## CORRIGENDUM - 02 TO NIT NO-99017

**Subject: Corrigendum-02 to Tender enquiry for Pre-Bid Tie up with the GIS OEM for Supply & Services of 765kV GIS Pkg for POWERGRID's Substation Package SS-147T (Pendurthi & Srikakulam) Tender / Project.**

**Amendment No. II (Technical)**

**Clarification-I (TECHNICAL)**

ELEVATION -A

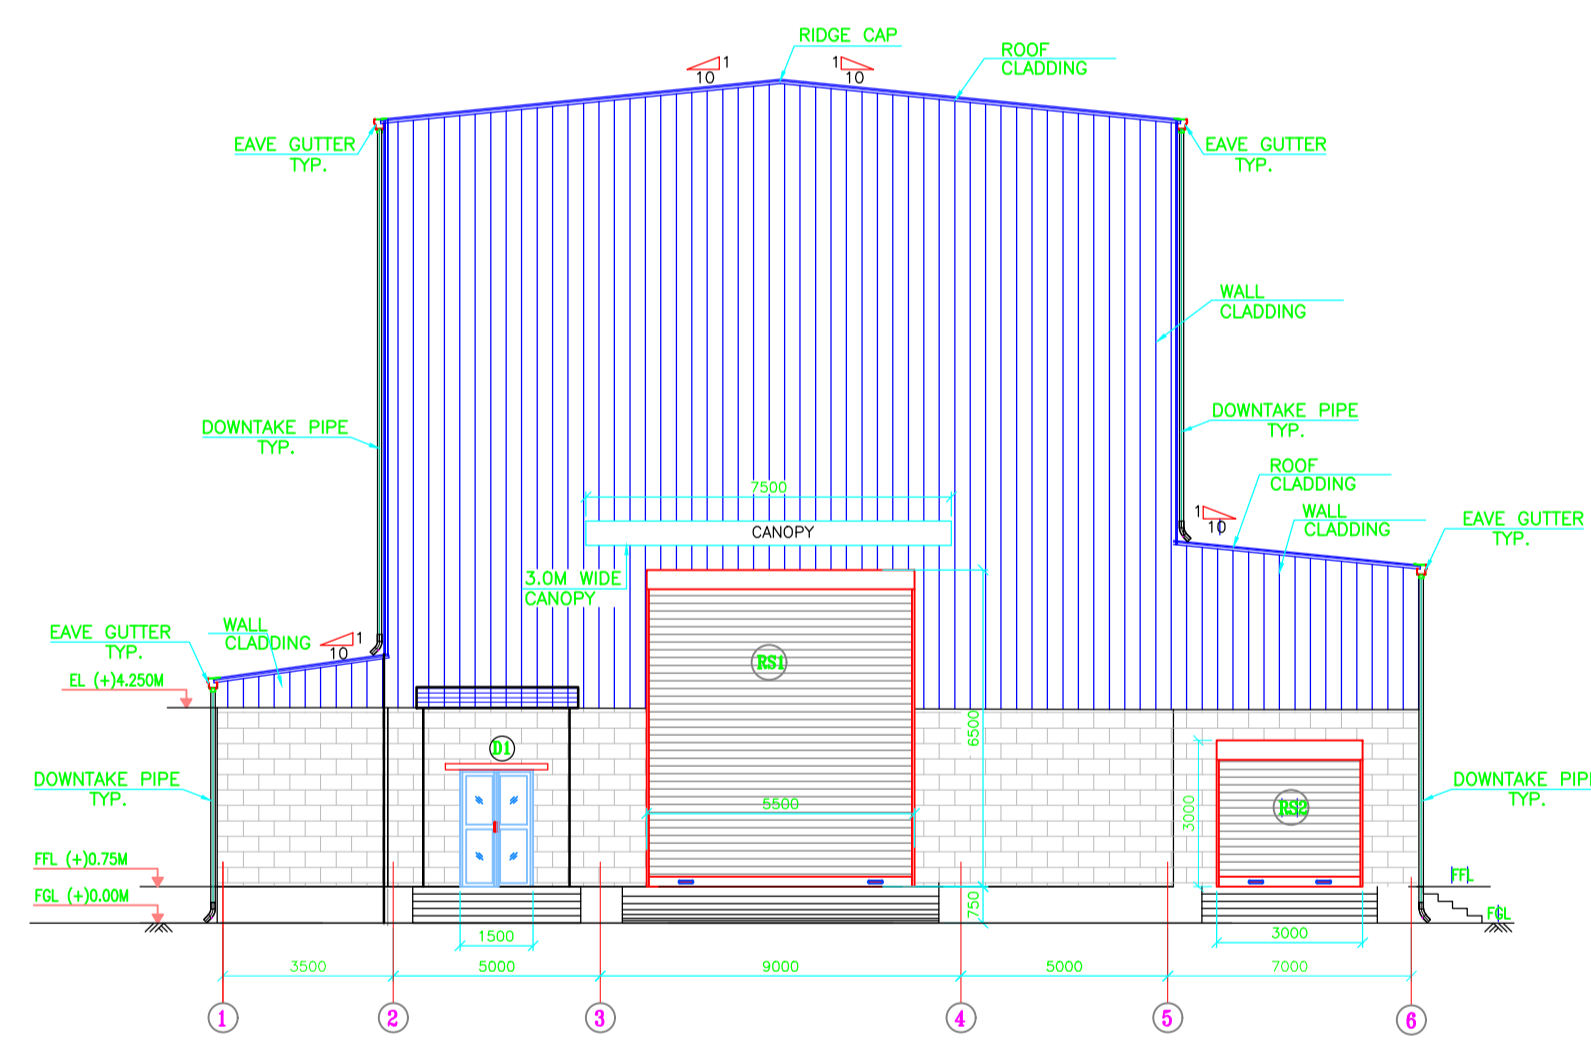
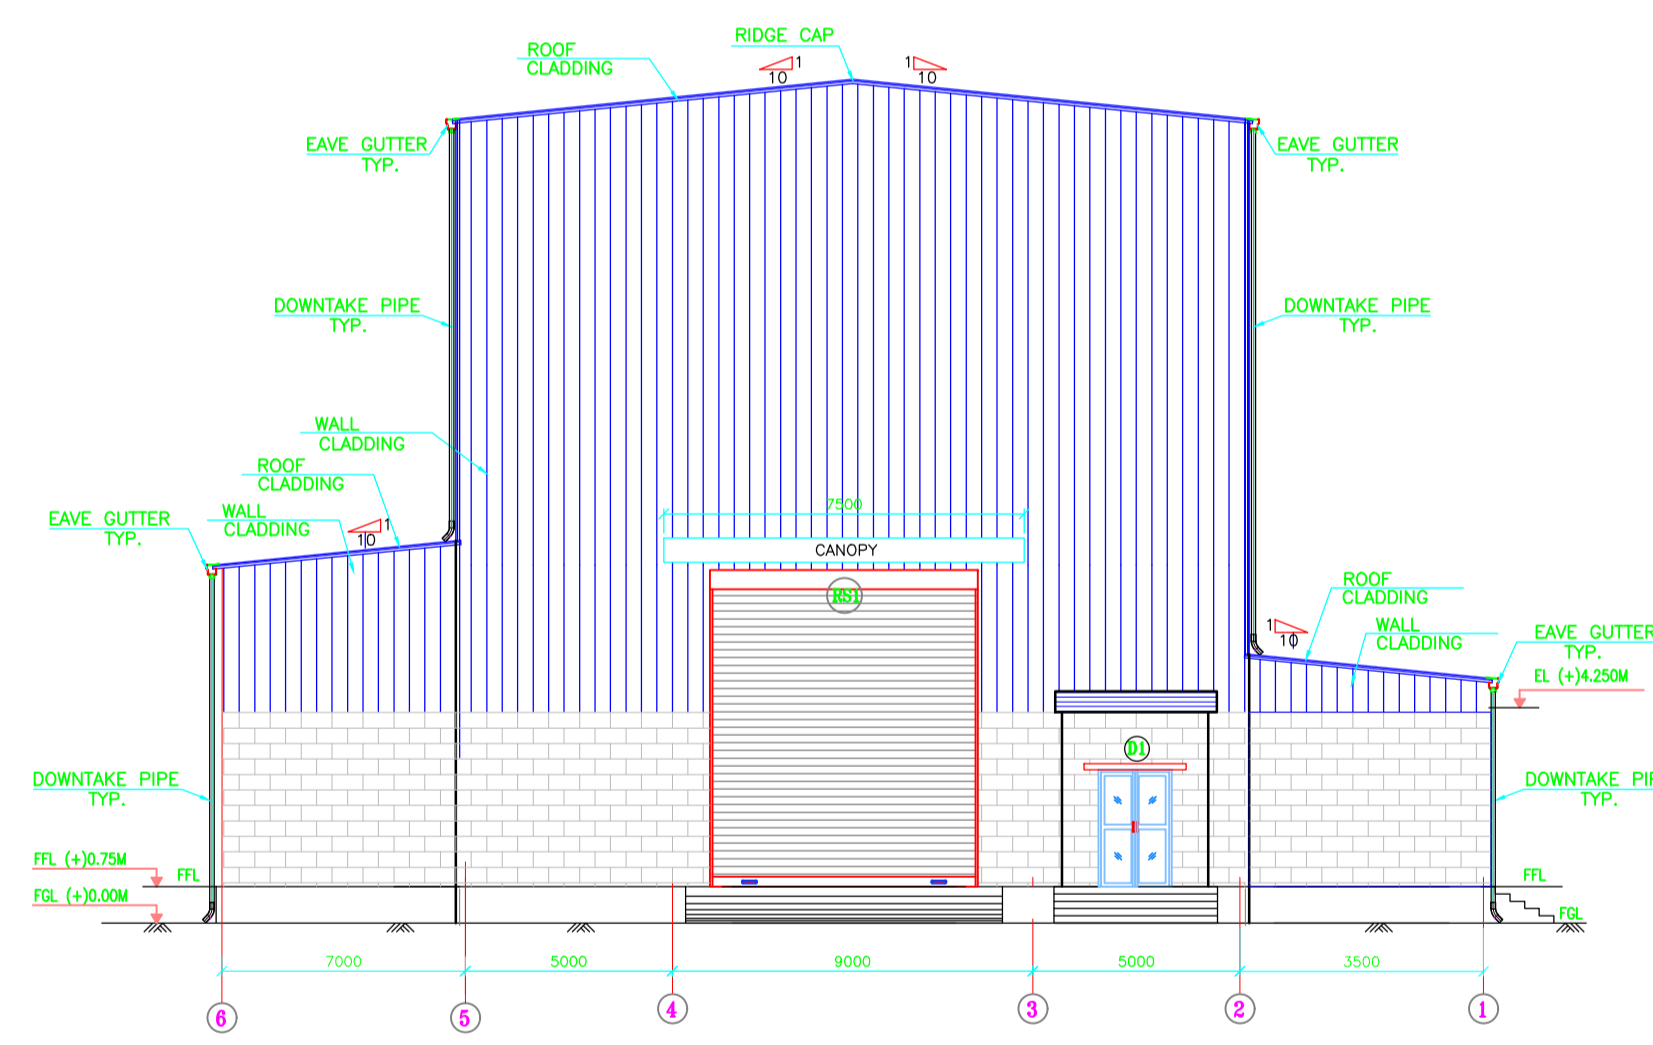
Sr. No.	Drawing No.	Description	Rev																														
<b>Electrical Drawings</b>																																	
2.	C/ENGG/CIVIL/765KV/GIS/ARCA/H/DRW/01	STANDARD 765kV GIS BUILDING ARCHITECTURAL DRAWING	R0																														
<b>Drawings of Existing Substations</b>																																	
Sr. No.	Drawing No.	Description																															
<b>765kV Srikakulam GIS SS</b>
